First National Bank - Germantown: Preliminary Plan Amendment No. 11985200A and Site Plan No. 820180140

Description

- A. First National Bank - Germantown: Preliminary Plan Amendment No. 11985200A:** Application to replace an existing restaurant use with a 3,270 square foot bank with a drive-thru; 0.70 acres; GR-1.5 H-45 Zone; located on the southwest quadrant of the intersection of Germantown Road and Crystal Rock Drive; 2009 Germantown Employment Area Sector Plan.  
*Recommendation – Approval with conditions*
- B. First National Bank - Germantown: Site Plan No. 820180140:** Request to replace an existing Pizza Hut restaurant with a 3,270 square foot bank with a drive-thru; 0.70 acres; GR-1.5 H-45 Zone; located on the southwest quadrant of the intersection of Germantown Road and Crystal Rock Drive; 2009 Germantown Employment Area Sector Plan.  
*Recommendation – Approval with conditions*

Figure 9 – Proposed Shared Use Path

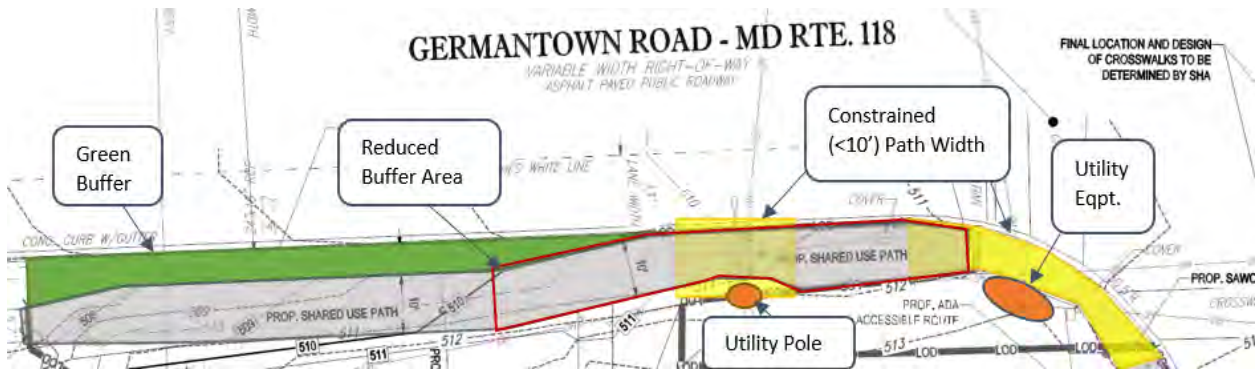
The 2018 *Planning Board Draft Bicycle Master Plan* recommends a 10-foot wide side path on both sides Germantown Road, although, as of writing, the 2018 Bicycle Master Plan has yet to be adopted. While the 2005 Bicycle Master Plan also calls for a shared use path along this section of

Germantown Road, the 2005 Plan had required a lower eight-foot minimum width, which is provided and exceeded for most of the facility. The Applicant nevertheless proposes to build this facility in substantial conformance with the 2018 Bicycle Master Plan along the south side of Germantown Road at the in the southwest corner or the intersection of Germantown Road and Crystal Rock Drive, running for approximately 160-feet. Due to several site constraints including grading and the presence of multiple utility poles and intersecting utility equipment, the path will not have the full ten-foot minimum width and five-foot green buffer between the curb and the path as recommended in the 2018 Bicycle Master Plan along its full length, as detailed in Figure 9 below.

The path proposed to have variable width, ranging between ten-feet and eight-feet with a variable width buffer as well; it will for the most part maintain the eight-foot minimum width of the 2005 Plan. At its most constrained point, at the intersection with Crystal Rock Drive (right side of Figure 9), the path will not be improved from the current condition. The existing intersection utilities severely constrain this area; a pole carrying two legs of the intersections’ signaling is placed approximately seven-feet from the curb line. The curb cannot be extended as the existing 30-foot radius is required to allow adequate fire and rescue vehicle movement. As a result, the existing five-foot-wide landing area will be maintained. It will not be upgraded as it is expected that the intersection will be upgraded in the near future by others.

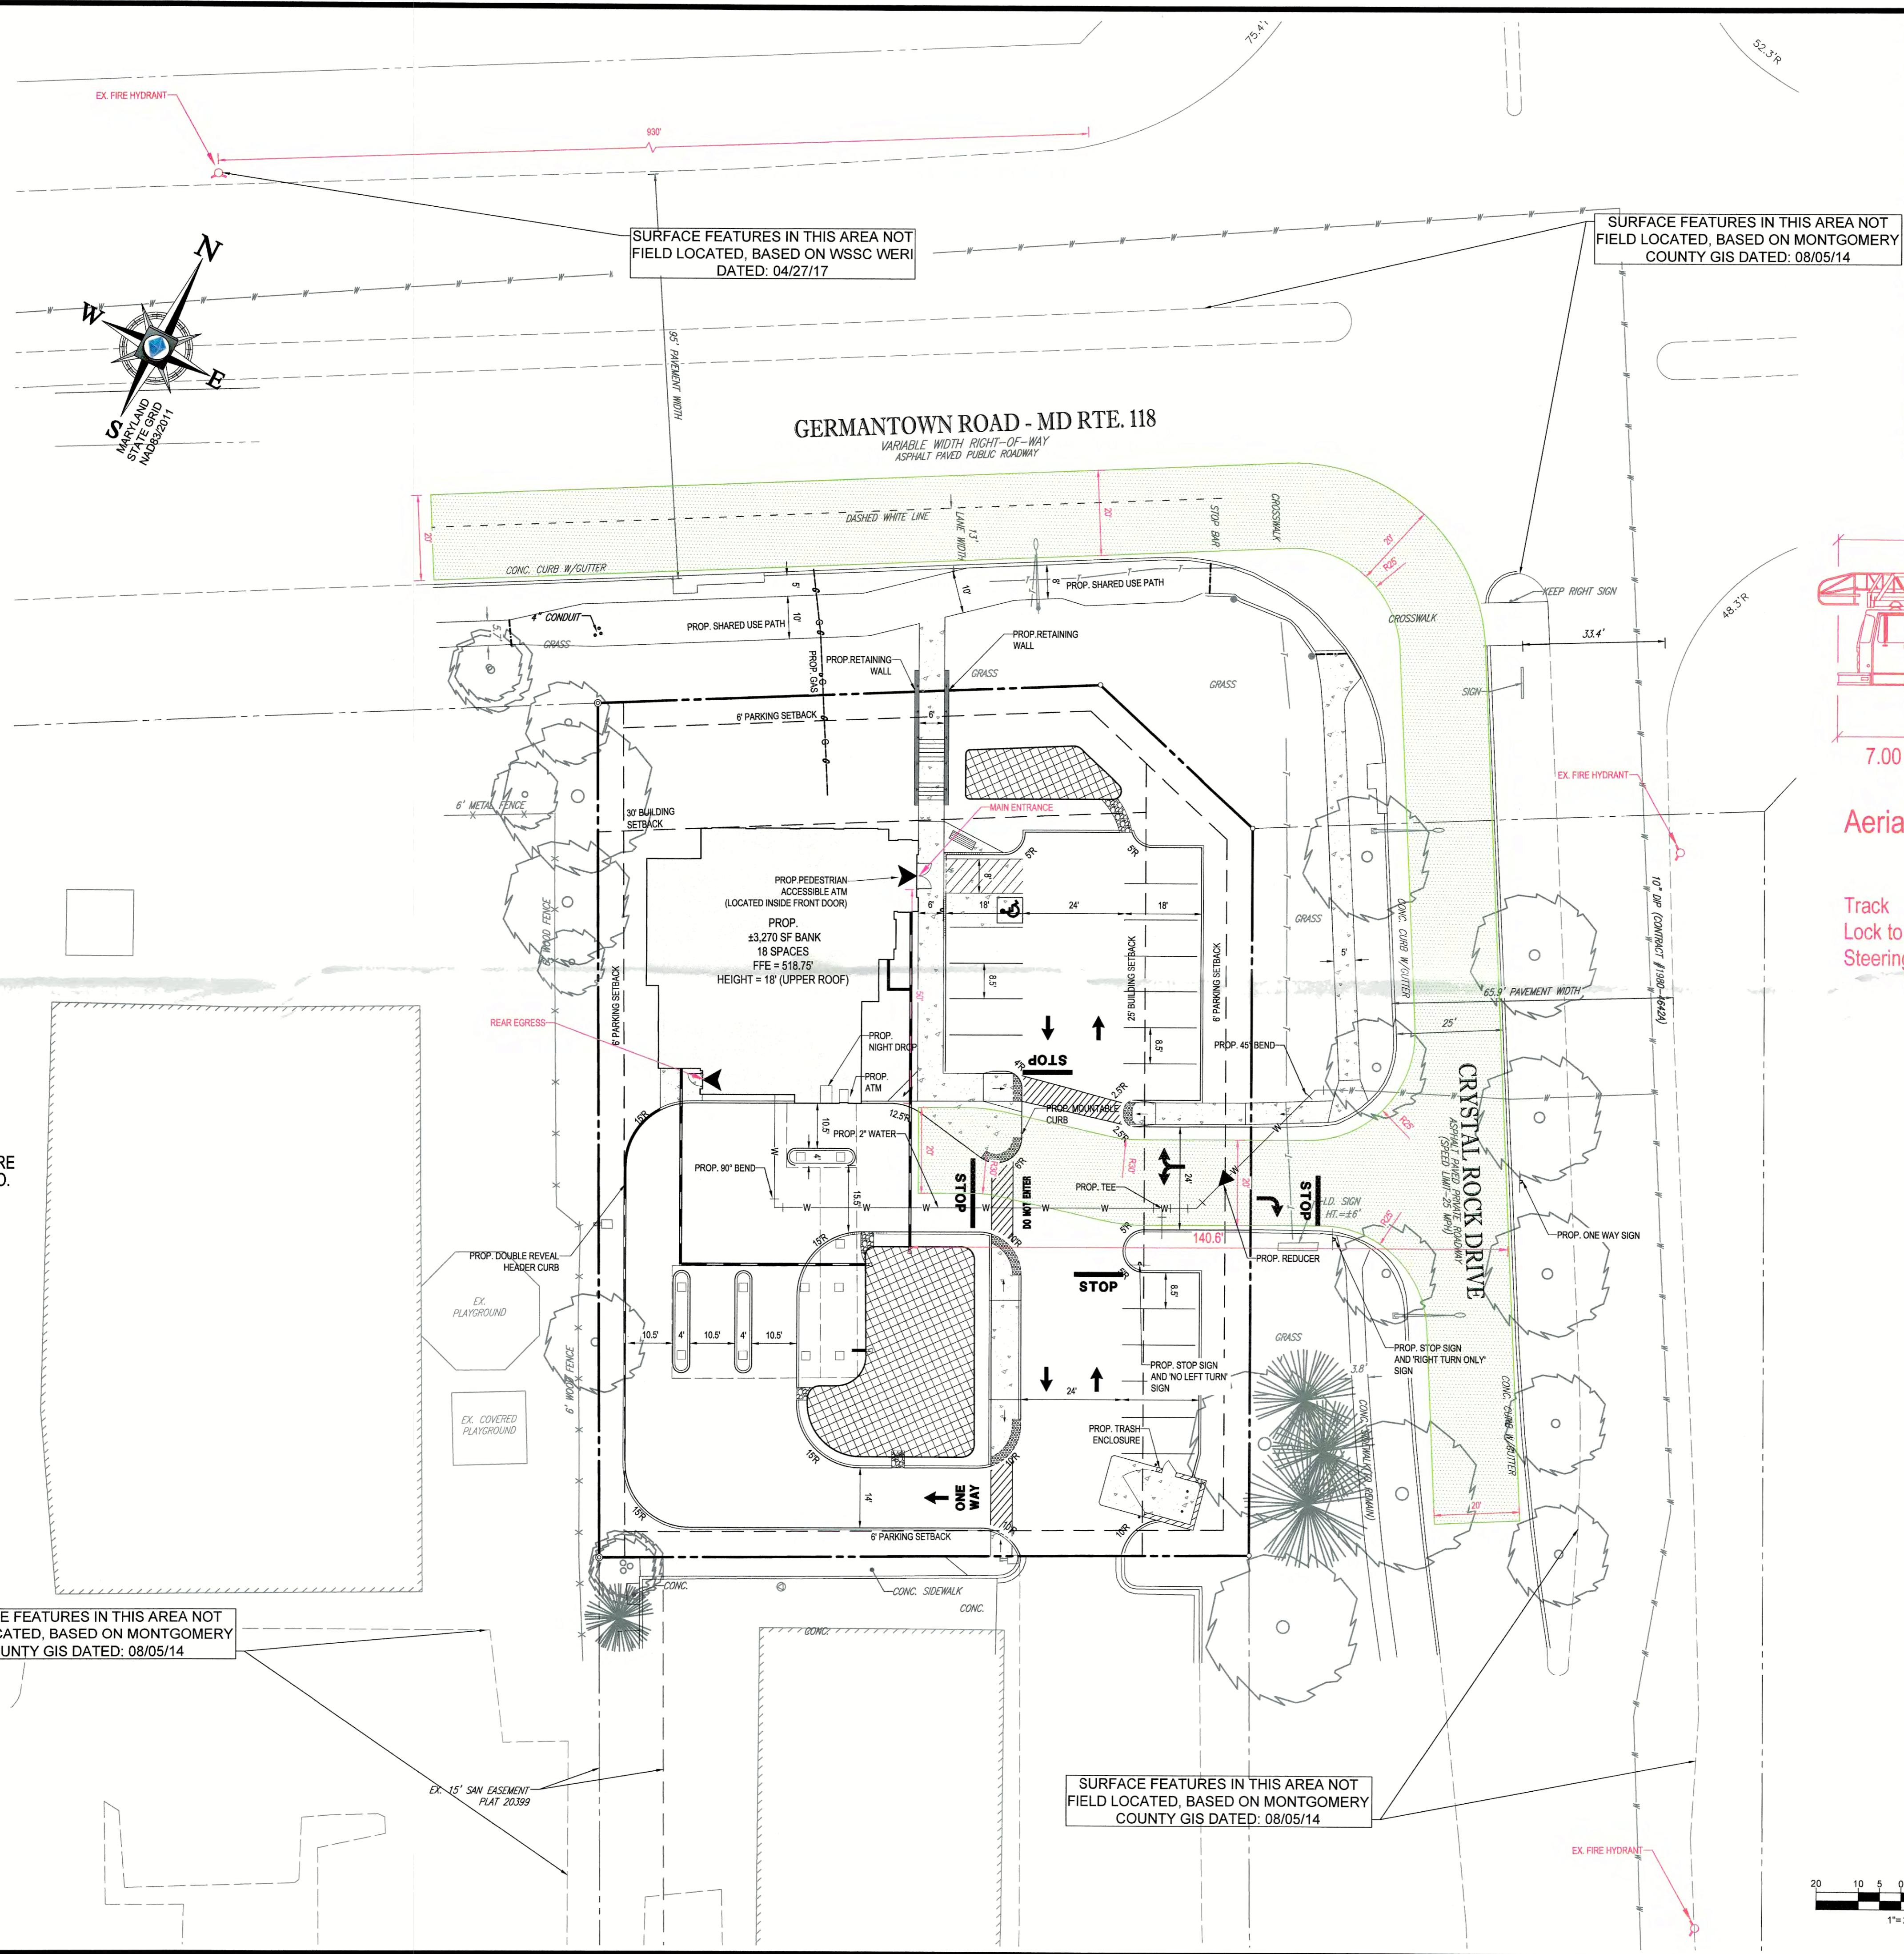
- 1. SHEET C-3:** Minimum width for a shared use path is 10'. Anything less will need an approved design waiver.
- 2. SHEET C-3:** The proposed Shared Use Path has a location that have a change of direction where the proposed Shared Use Path and sidewalk meet. A landing area will need to be provided at that location. The landing area will need to be the width of the Shared Use Path and sidewalk and must be 2% in both directions. Provide this note on the plan sheet for that location. "**Landing Area 10'x 5' and 2% in Both Directions**".

- 3. SHEET C-3:** The existing curb ramps at the intersection of Germantown Road and Crystal Rock Drive are non-compliant and will need to be reconstructed to a Maryland Standard Curb Ramp.

- 4. SHEET C-3:** The existing ramps at the intersection of Germantown Road and Crystal Rock Drive are non-compliant and will need to be reconstructed. **Per SHA policy, when one leg of an intersection is being upgraded, all ramps must be upgraded to ADA Compliance. Curb cuts/curb ramps should be installed or upgraded to current standards at every leg of the intersection.**
